FIELD CORRECTION NOTICE

LOCATION 785 CRIPPLE CREEK PERMIT NO. 01254

RESIDENTIAL PLAN CORRECTION SHEET

ADDENDUM TO Permit No. 01259
Owner THOMAS ACHEMEIER
Contractor BOB ZACHRICH
Location 785 CRIPPLE CK.

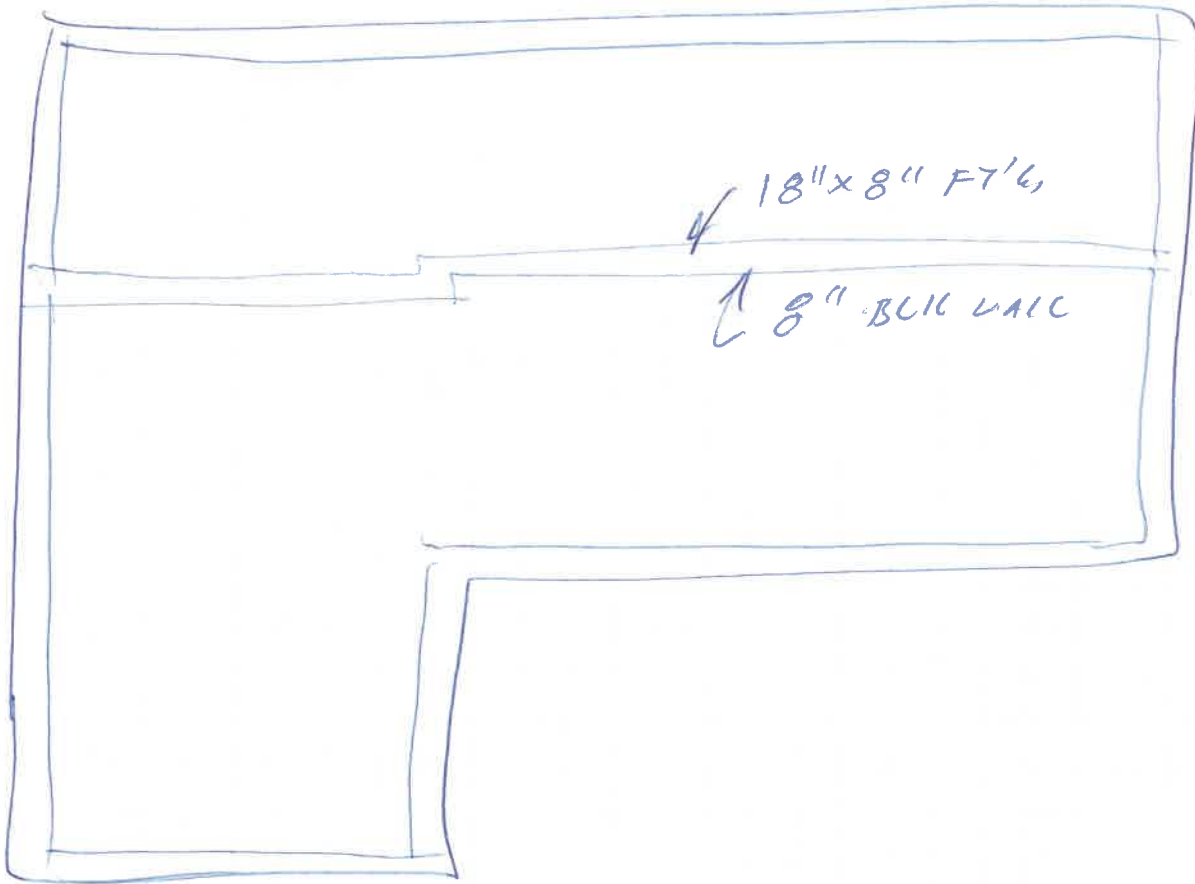
GARAGE CEILING JOISTS SPAN NORTH
SOUTH

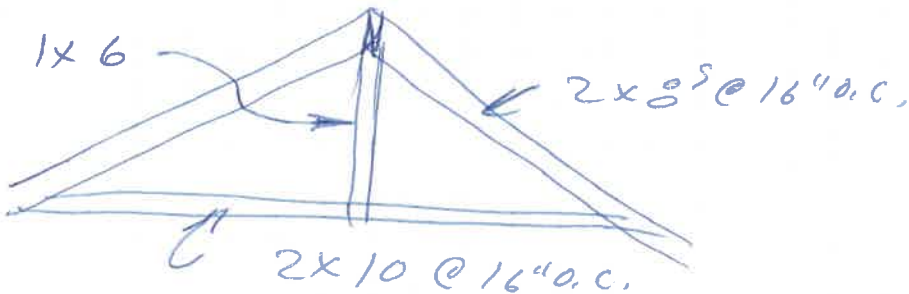
FLOOR JOISTS O.K.,
FREE STANDING STOVE

PLOT PLAN

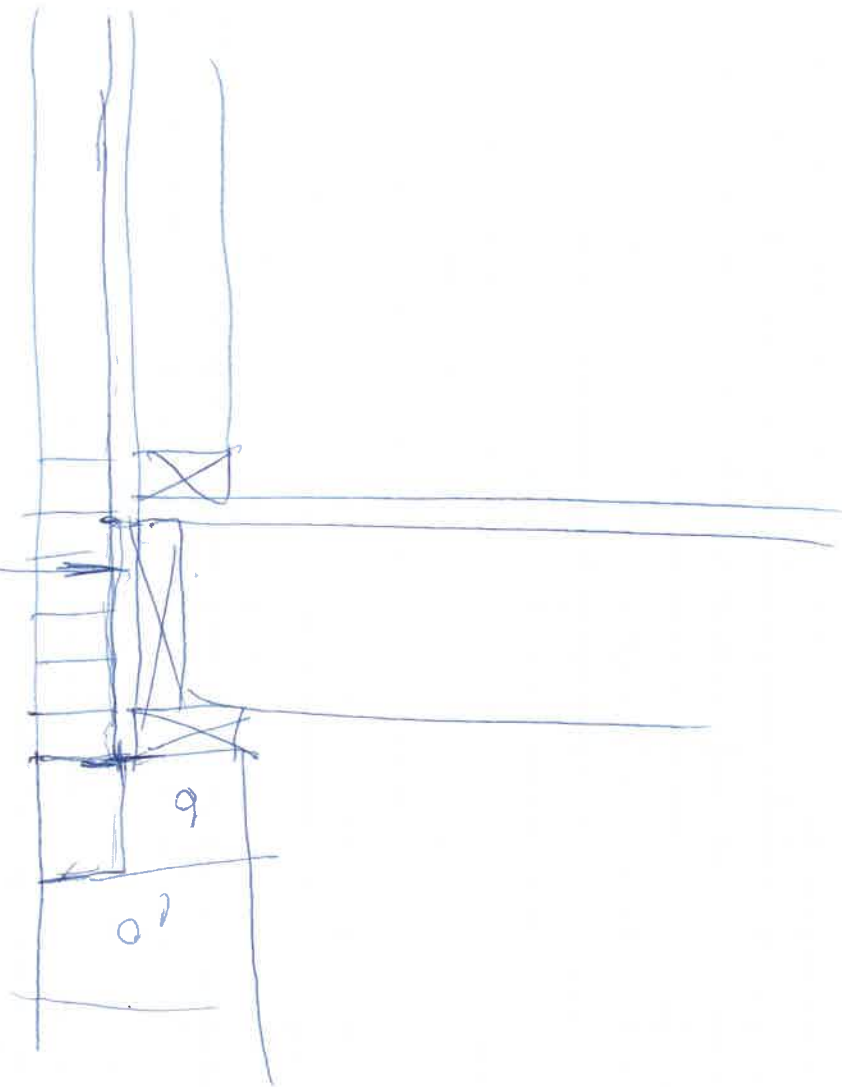
FELT PAPER
OR SHEATHING
TO SILL
